Section 42A Report

Report on submissions relating to Plan Change 62

LEESTON

Hearing Commissioner – D Chrystal
Strategy and Policy Planner – J Lewes
15-16 September 2020

Figure 3 – Area of rezoning requested by Cochranes of Canterbury

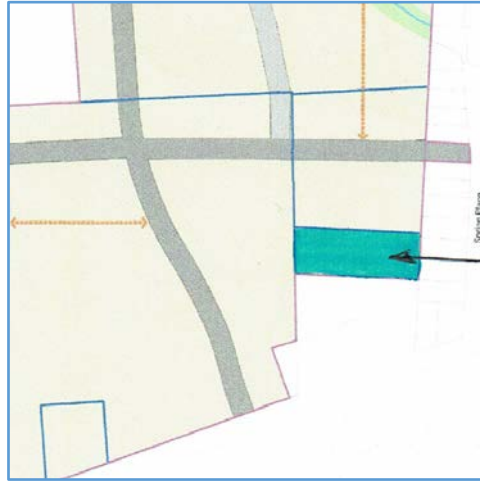
- 7.17. Two of the submissions received have requested that parts of the plan change area be zoned differently from that proposed in the plan change request.
- 7.18. The submission from Cochranes of Canterbury has requested that a portion of the land at 125a High Street be zoned Business 1, in keeping with the historical use of that area as part of the existing business operating from the site.
- 7.19. Cochranes of Canterbury has recently been granted approval for a boundary adjustment (RC185563) to adjust the existing boundaries of the site at 125a High Street, Leeston, retaining two allotments. Lot 1, being the northern portion of the site has an area of 1.7689 ha, and Lot 2, being the balance, has an area of 5,344 m². As part of the consent, Lot 2 is to be amalgamated

with Lot 1 DP317397, being 125 High Street. Section 224 was granted in June 2020. This boundary adjustment aligns with the rezoning requested by Cochranes. Below is an extract from the submission from Cochranes of Canterbury, highlighting the area in question in blue.

- 7.23. I consider that there are possible scope issues with the relief sought by both Cochranes of Canterbury and Ms Farrant, and consider it unfortunate that neither party elected to participate in the plan change when invited to do so.

- 7.26. The submissions of Cochranes of Canterbury and Ms Farrant seek amended zoning from that which was notified. While there may be a strong argument for both changes in zone based on good planning practice, I cannot support either submission on the basis that the neighbouring properties which may be affected by a change of zoning could not reasonably expect such an outcome from a reading of the plan change and they would have been denied the opportunity to participate. Although there is the opportunity with a plan change for further submissions, this relies on a person formerly not affected or not interested to be sufficiently alerted. I also note that the s32 analysis, as well as all the other evidence provided in support of the application, have not considered a change of zoning to these two areas.

Appendix 2 – Proposed Outline Development Plan

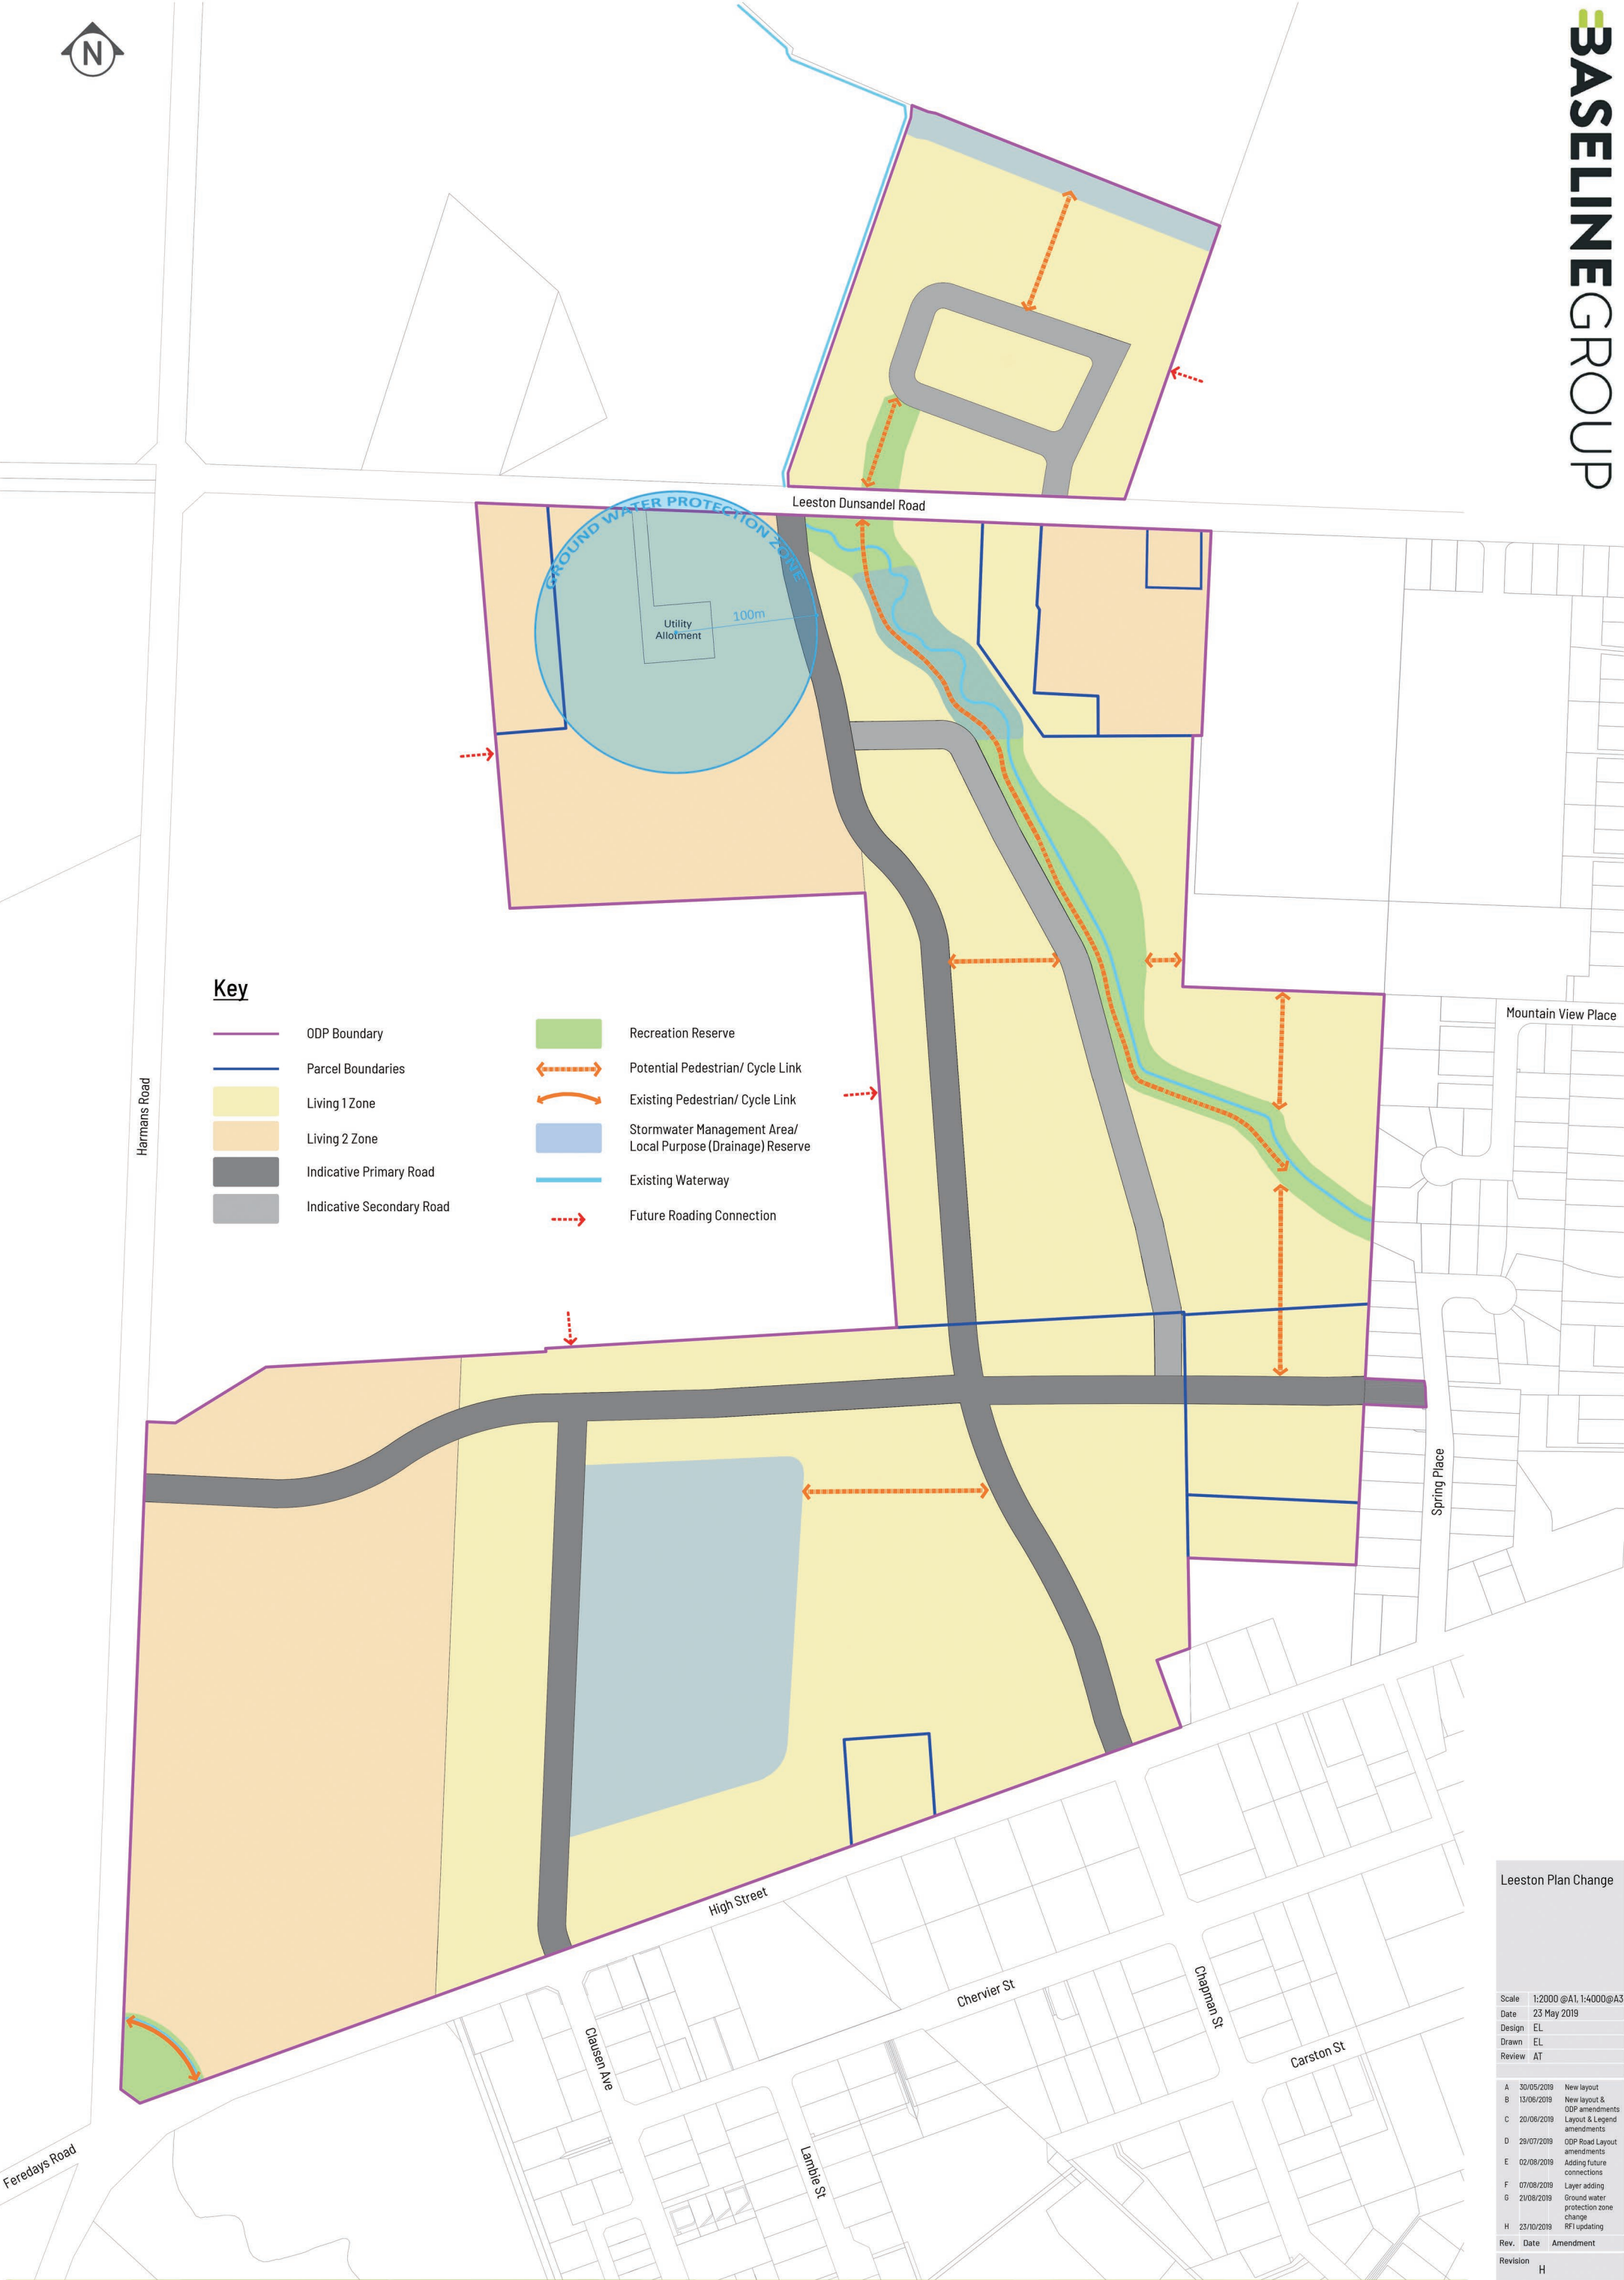
- 7.50. Mr Mazey generally supports the roading and transport layout shown on the ODP, and while he acknowledges the concerns of the submitters regarding the proposed connection through Spring Place to the plan change area, he sees that the connection will improve connectivity and access resilience for all modes of transport. Mr Mazey observes that the nature and built form of the existing urban area means there are limited opportunities to integrate the site with the township. The exception to this is the proposed connection through 18 Spring Place. This parcel of land, which is the equivalent width of a standard lot, appears to have been retained for a long time as a future roading link to the plan change area to the west.

- 7.51. However, in recognition of the concerns of the submitters, Mr Mazey considers that, as shown on the ODP, the section of road west of Spring Place should be downgraded, and shown as a secondary road. This would be the equivalent of a Local Intermediate Road⁹ classification under the Plan, which allows for roads up to 8m wide and is more in keeping with the width of Spring Place. Together with providing an engineered threshold treatments to reduce the secondary road carriageway width further, this would remove the attractiveness of this route being used by traffic accessing the wider site from High Street. I concur with this recommendation, and have proposed amendments to the ODP, as set in Section 9 and Appendix 2 below. The requirements and design of this connection/intersection should be addressed as part of any future subdivision and engineering approval processes.

(As discussed in the body of this report, it is considered that only the overall plan layer should be included in the Plan, should the plan change be approved. This is consistent with the approach taken in the proposed district plan, of consolidating information from multiple layers into the one ODP.)

- 7.61. I accept Mr Mazey's advice and consider that there are no transport related reasons why the plan change should not be granted, subject to the minor amendments to the ODP discussed above.
